2013NTH009 – MODIFICATION TO DA2012/185 MARY'S MOUNT BLUE METAL QUARRY

In response to issues raised at the Joint Regional Planning Meeting regarding the Mary's Mount Blue Metal Quarry held on 9 April 2014, we wish to lodge the following amendments to DA2012/185.

PROPOSED QUARRY SITE PLAN

HAULAGE OPERATIONS TO CEASE AT SCHOOL BUS TIMES

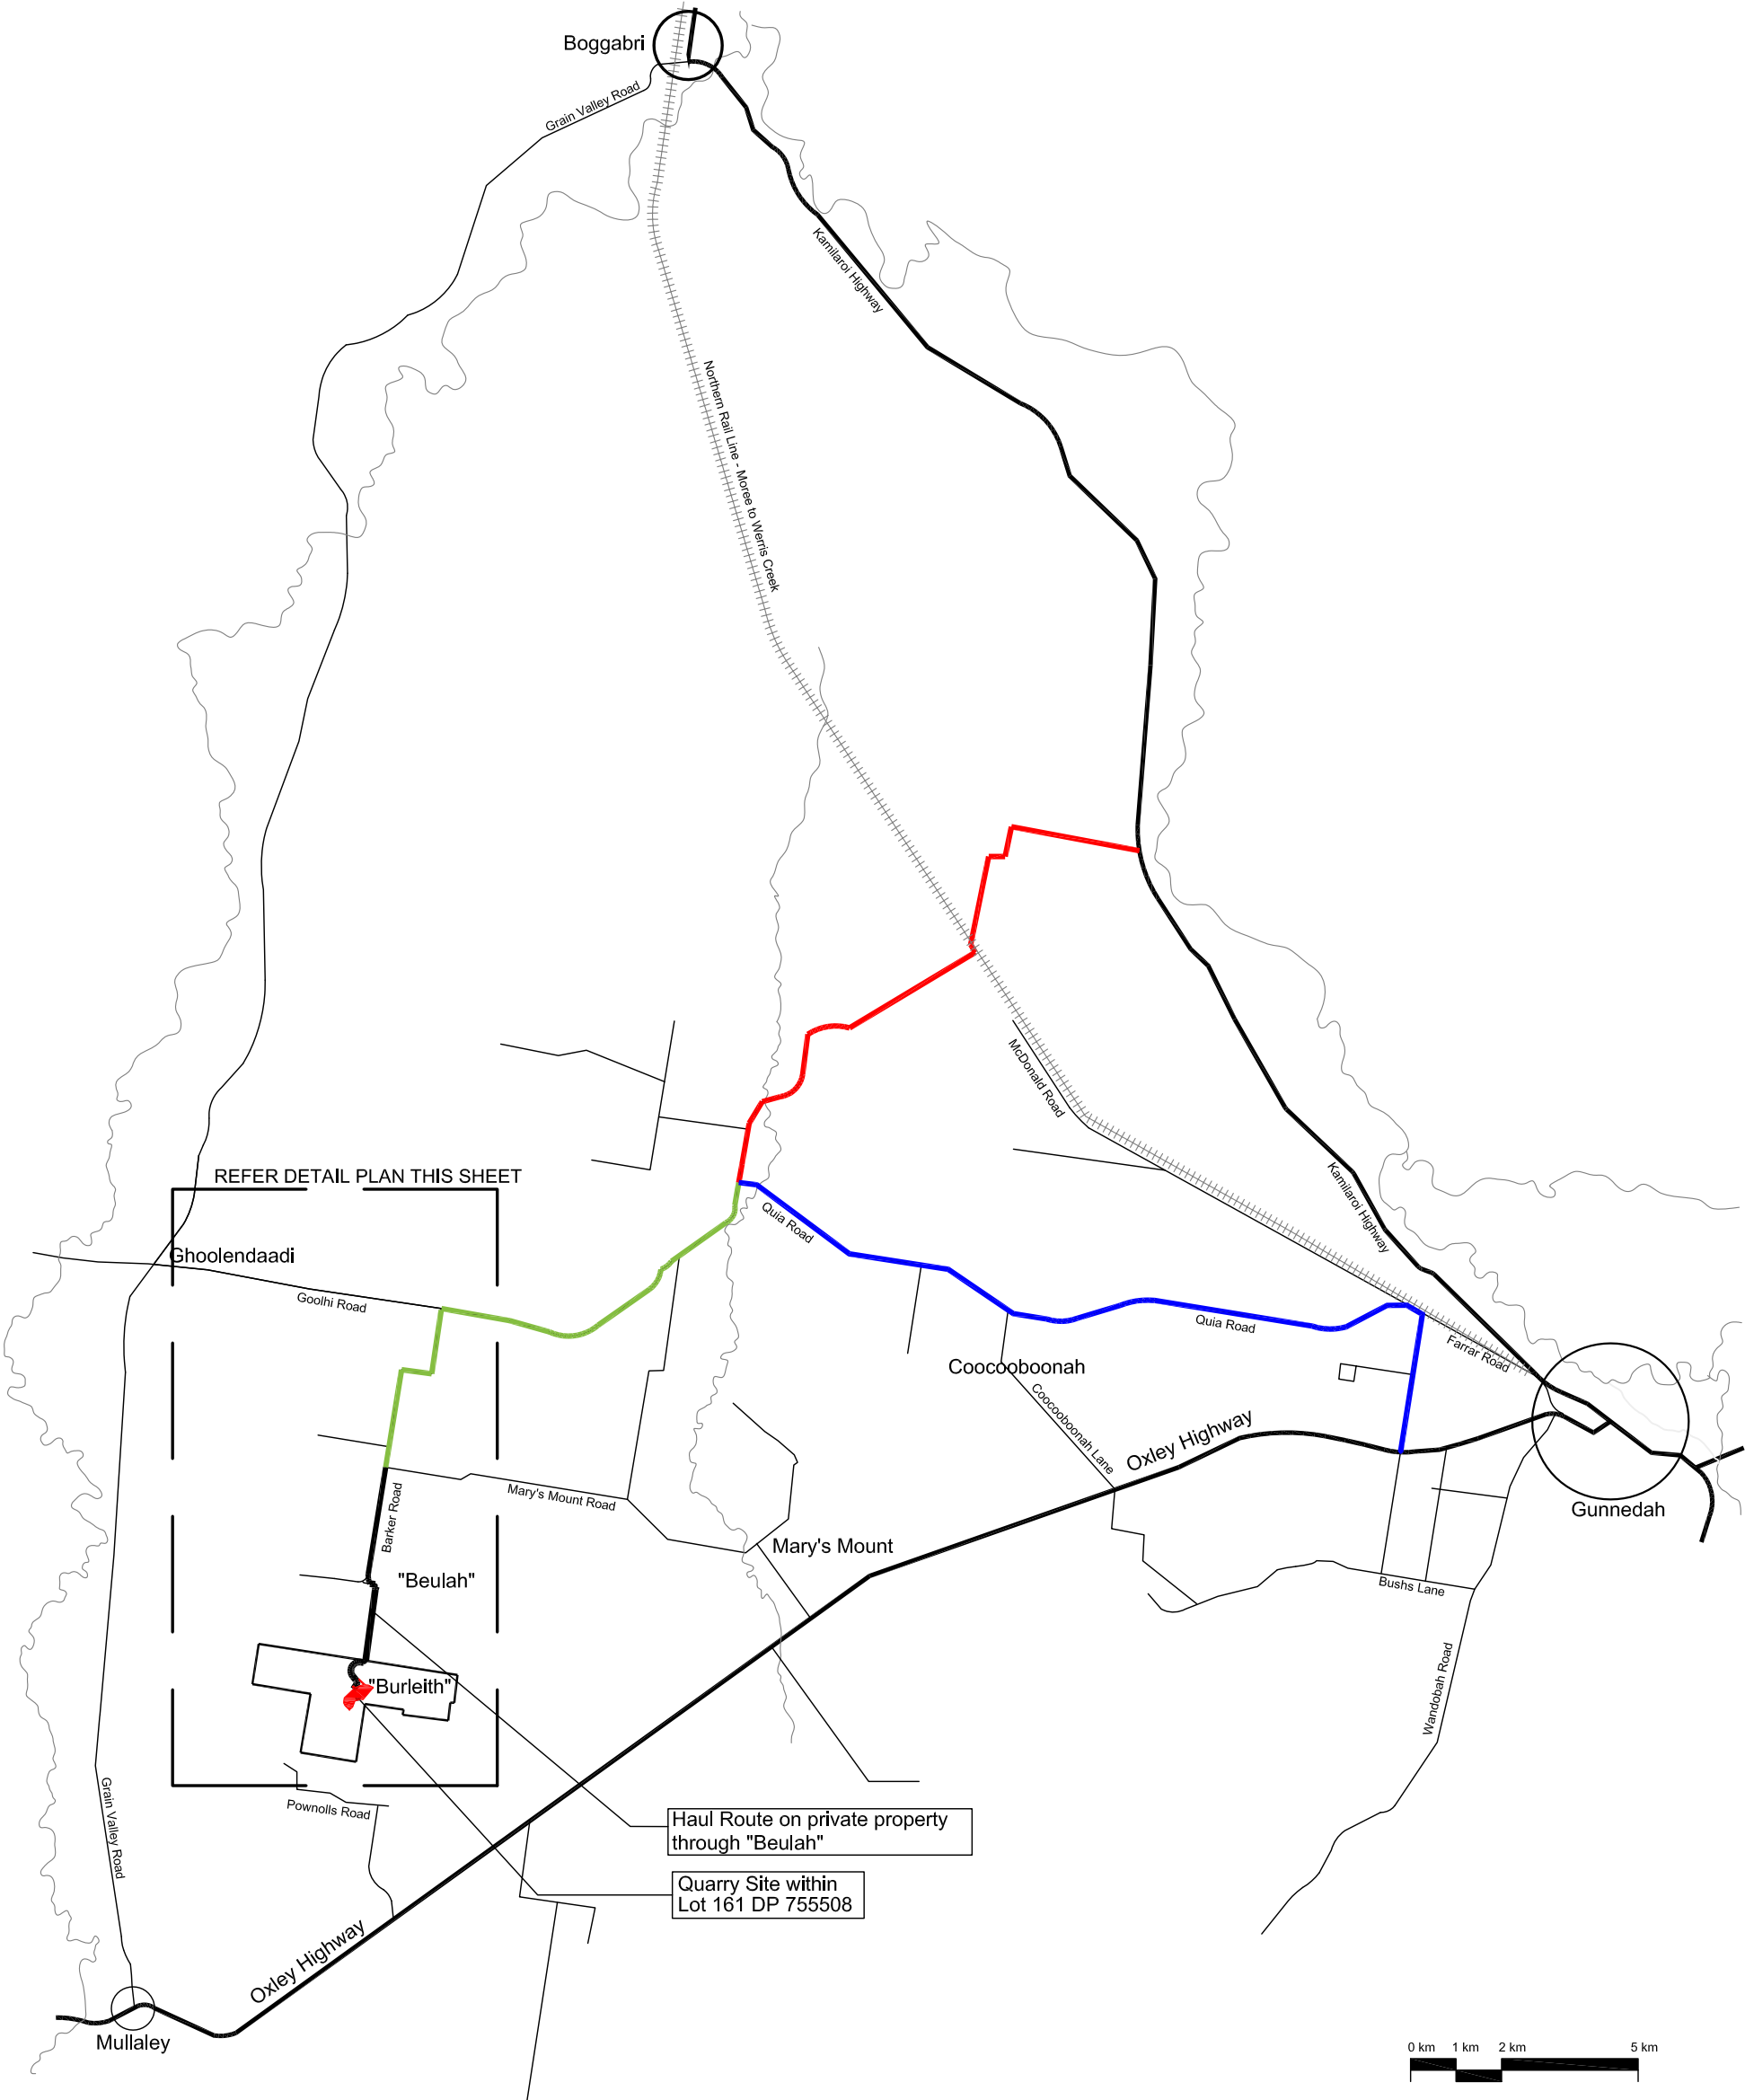
Gunnedah Quarry Products proposed to cease operations for the following times when the school bus is travelling along the haul route (school term only):

Mary's Mount Rd to Quia Rd
7:50am- 8:10am and 3:50pm- 4:10pm

Emerald Hill to Quia Rd
7:50am – 8:10am and 3:50pm – 4:10pm

Quia Rd to Gunnedah
8:00am – 8:30am and 3:30pm – 4:00pm

This haulage schedule has been illustrated in the attached figure – Haulage operations to cease at school bus times.

We ask Gunnedah Shire Council to amend the draft Conditions of Consent to include Quarry operator is to cease haulage operations while school buses are using the haul route as recommended in the TIS.

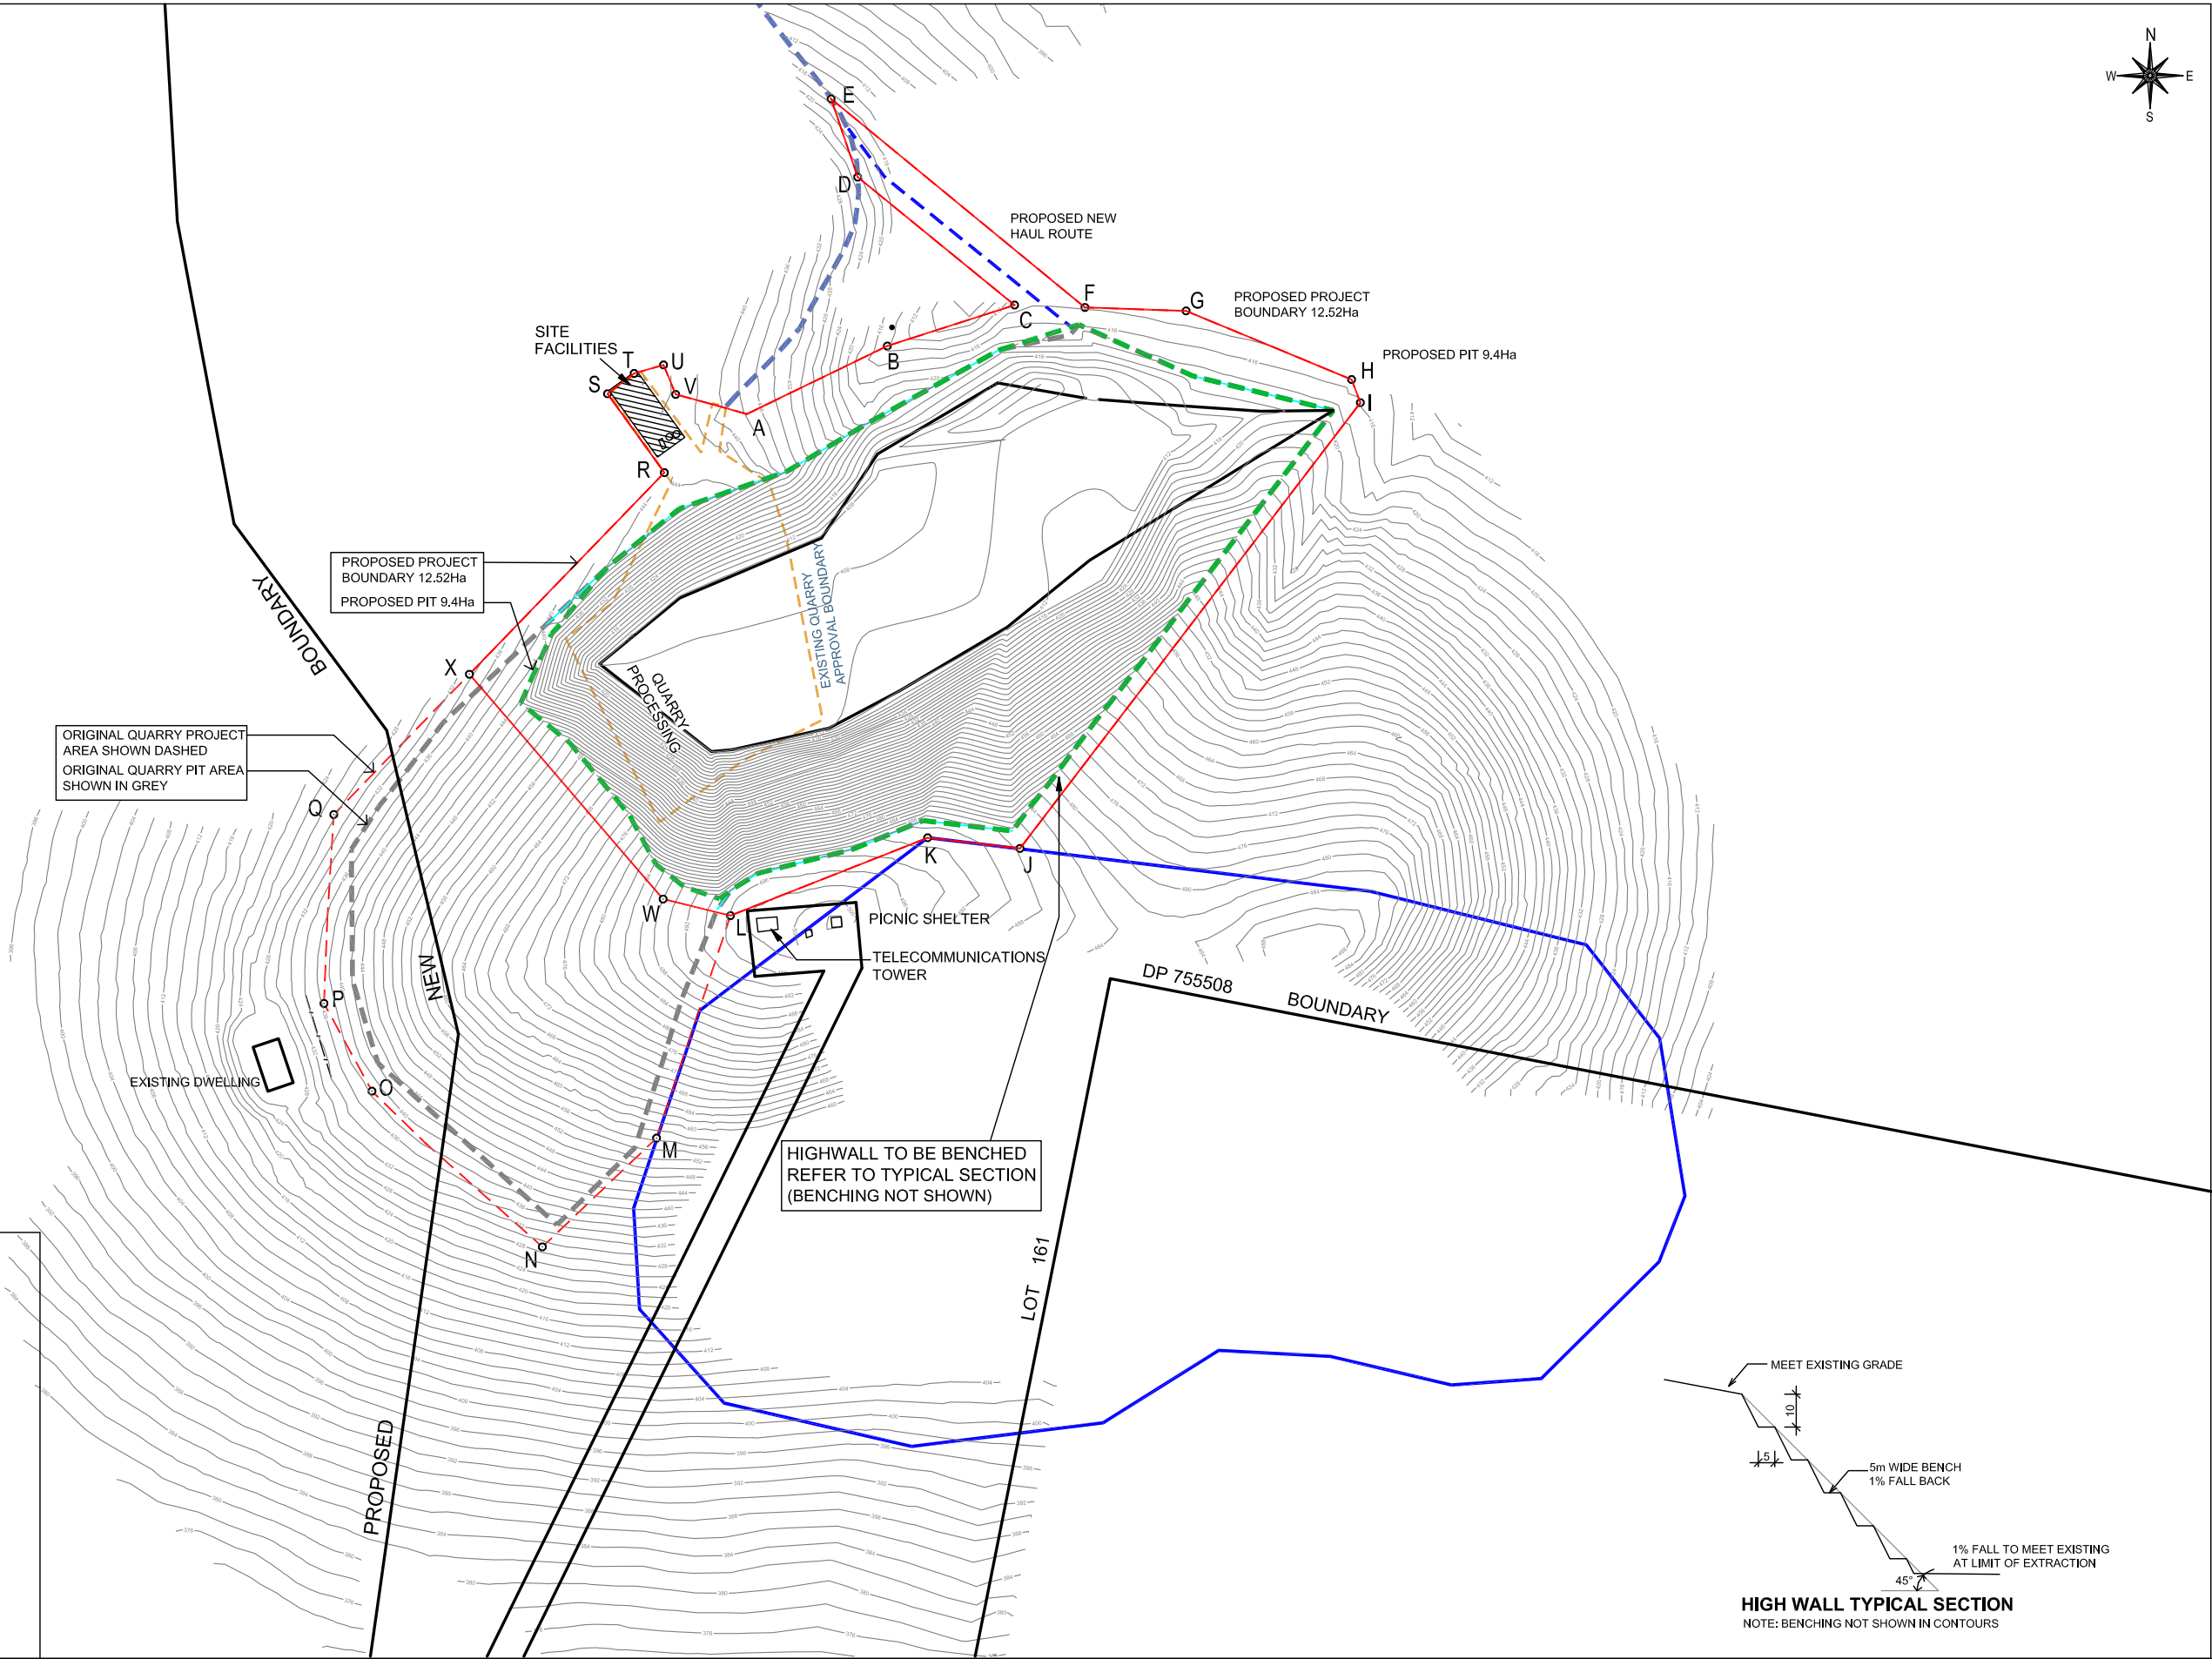
As to the subdivision of the quarry site from the Burleith property, the quarry has been re-designed to provide an acceptable buffer between the "Burleith" residence and the proposed pit boundary. Plan 2 Proposed Quarry Site Plan Issue G illustrates the modified pit design and the changes are summarised below:

Item	Proposed Quarry Site Plan Issue F dated 25 March 2013	Proposed Quarry Site Plan Issue G dated 11 April 2014
Proposed Project Boundary	17.63ha	12.52ha
Proposed Pit	14ha	9.4ha
Proposed edge of Pit from dwelling	55m	250m
Estimated Total Extraction	4,438,700bcm	2,631,500bcm
Total Life of the Quarry	38 years	23 years
Total Period of Extraction	37 years	22 years

Table 2. Blast set-back distances

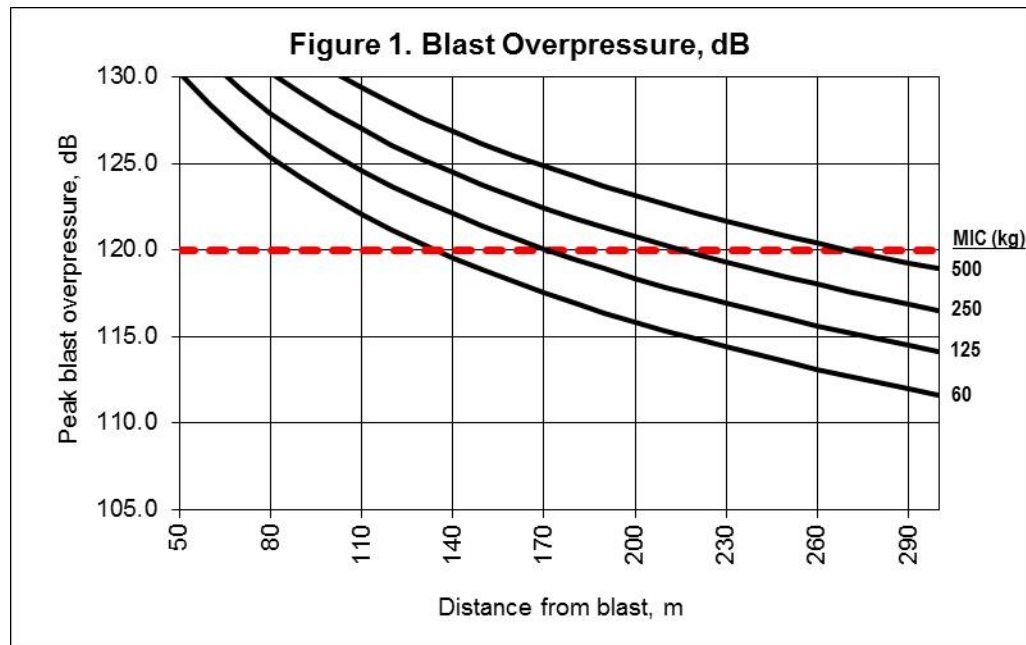
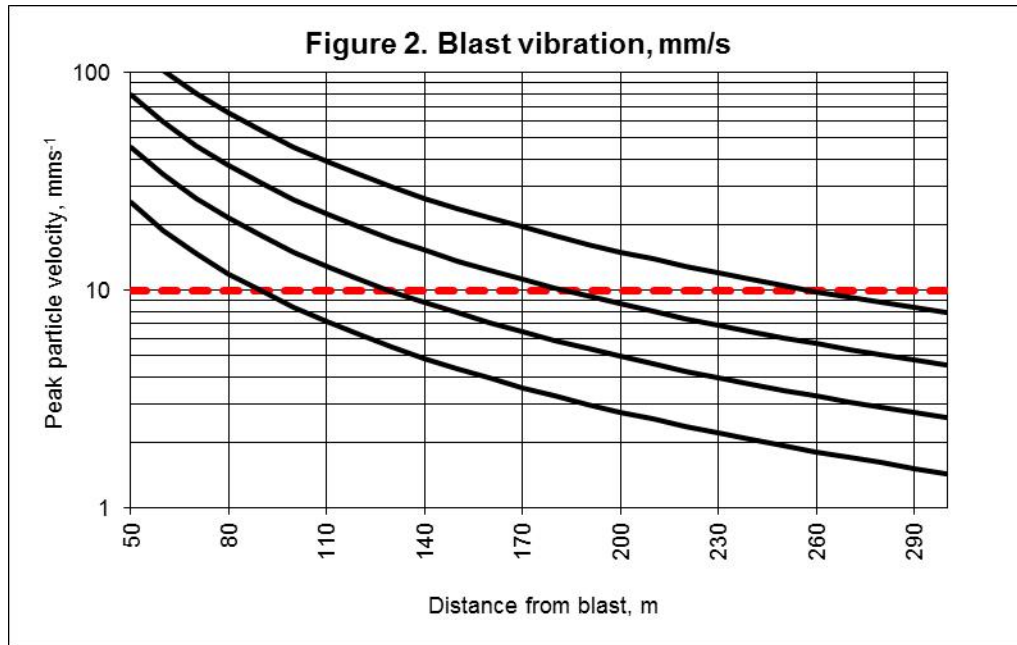
Blast overpressure and vibration calculations were performed for MIC values of 60kg, 125kg, 250kg and 500kg at distances from 50m to 300m from the blast. Results are shown in figures 1 and 2. Table 2 summarises the minimum set-back distances at which the adopted blast criteria are achieved for each MIC.

Table 2 shows that the required setback distance from the “Burleith” residence will be less than the proposed 250m setback for MIC values up to 250kg.
